## PRELIMINARY PLAT REVIEW PUBLIC HEARING

**FOR:** Eddyline Ranch Subdivision  
**WHERE:** W 4000 N & N 7000 N, SW of Tetonia  
**PREPARED FOR:** Board of County Commissioners  
Public Hearing of April 28, 2025

**REQUEST:** Harmony Design & Engineering, on behalf of STRR LLC., is proposing to create twelve (12) lots ranging from 32.3 acres to 39.22 acres from an existing 423.83 acre parcel. Lot 6 will be owned by the HOA to serve as the hub for community amenities including a pond and ranch camp clubhouse centered within the subdivision. A ranch manager employee housing cabin and maintenance barn will be located in the south portion of lot 6 near the intersection of Eddyline Drive and W 4000 N. The site was previously used for agriculture and is currently undeveloped.

Figure 7. Wildfire Hazard Overlay (lots 1- 6 – potentially 7 and 8 are within the Wildfire Hazard Overlay)

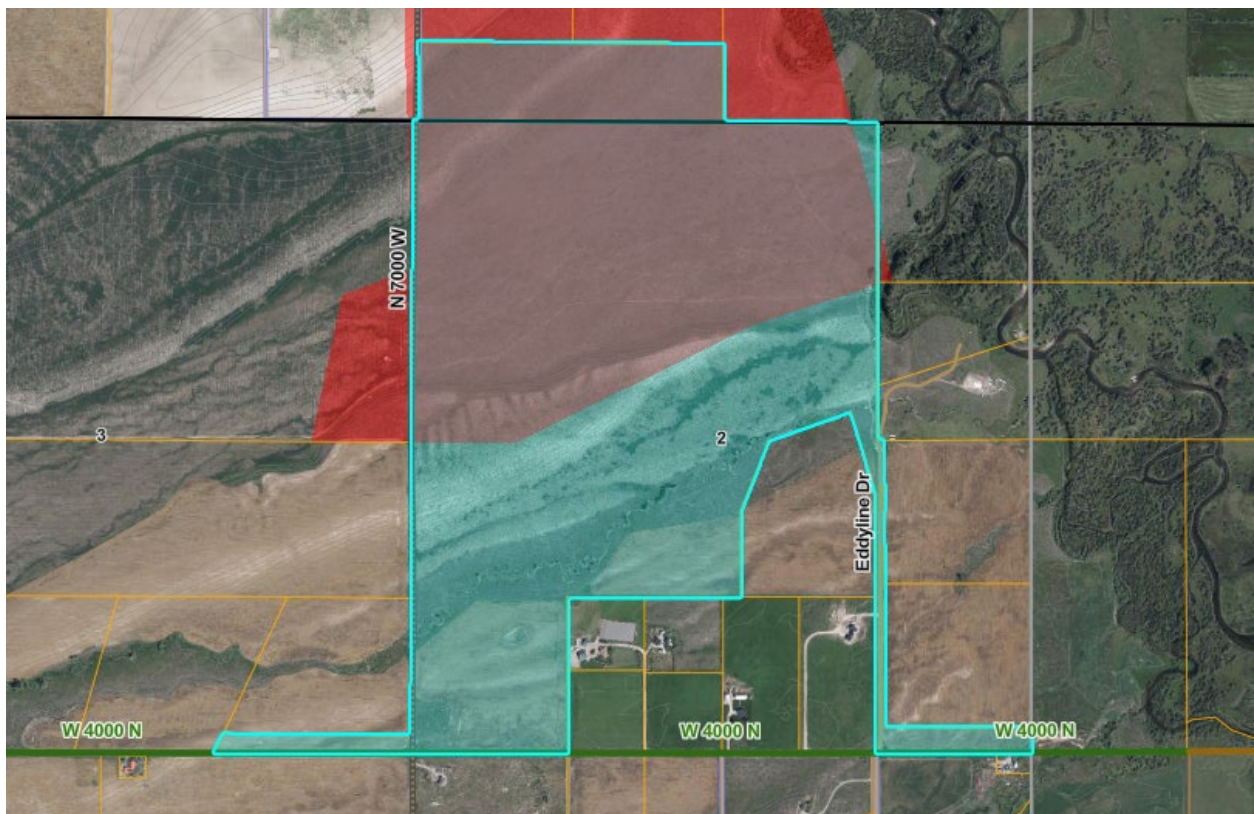
*Applicant has addressed the conditions of approval from the PZC hearing in attachment V. Staff concurs with the applicant's responses in general. Further discussion of Wildfire Hazard overlay (condition 1. a.) may be appropriate.*

Figure 8. Proposed Preliminary Layout

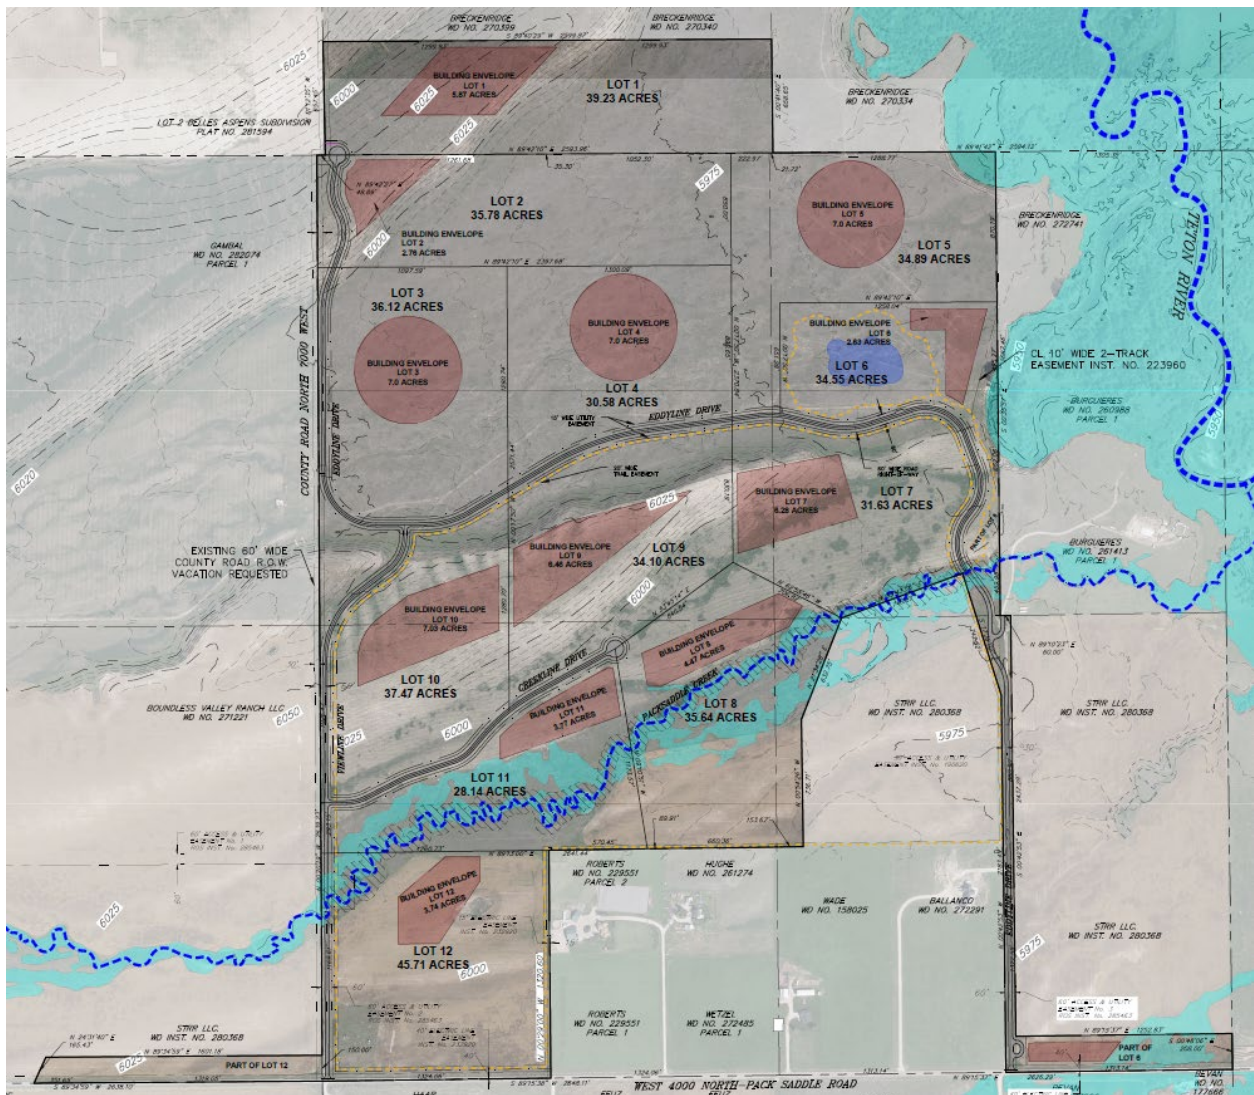
*Staff Comment: Some building envelopes appear to still not meet the requirements of LDC Section 5-4-3. Applicant still needs to obtain approval from EIPH. No IDWR permits have been received for the pond. IDWR has indicated no stream alteration permits are necessary. Access permits still need to be obtained. Recreational trails are still not shown on the master plan. All other conditions have been met.*

1. Building Envelopes
  - a. For lots 1 through 6 need to take the guidelines of LDC Section 5-4-3 into consideration. Building envelopes must allow for the development of all principal structures to be located within two hundred (200) feet of the primary public roadway.

- b. Building envelopes should also be placed to avoid steep slopes (LDC 5-2-5).
2. Receive preliminary approvals from EIPH prior to the BoCC Preliminary Hearing.
